## Product Change Notice (PCN)

PCN Number: **PCN-053-9036R-01**

Product(s) Affected: **CBL-UC-UC-1**

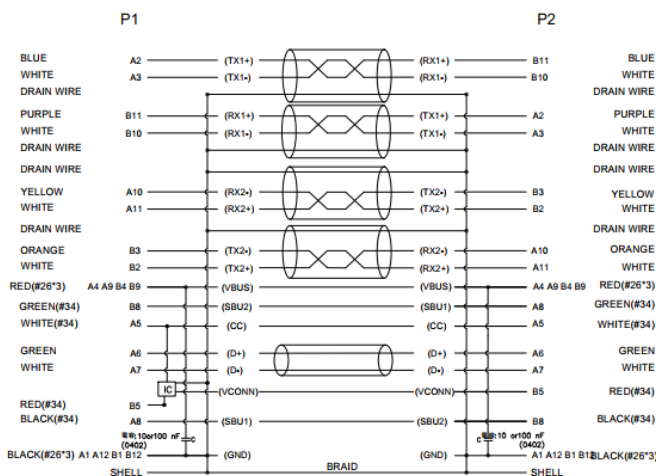
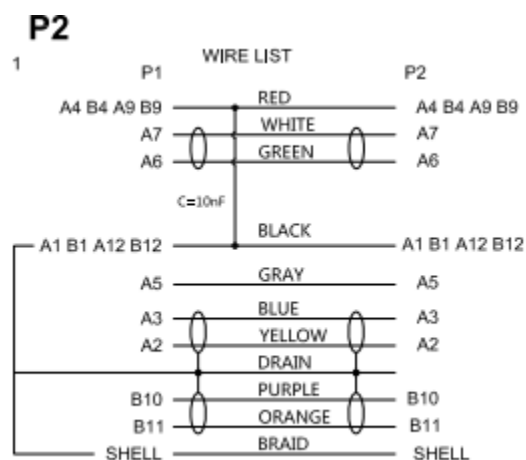
Description of Change: **Wiring Pinout configuration change. IC chip added to VCONN connection.**
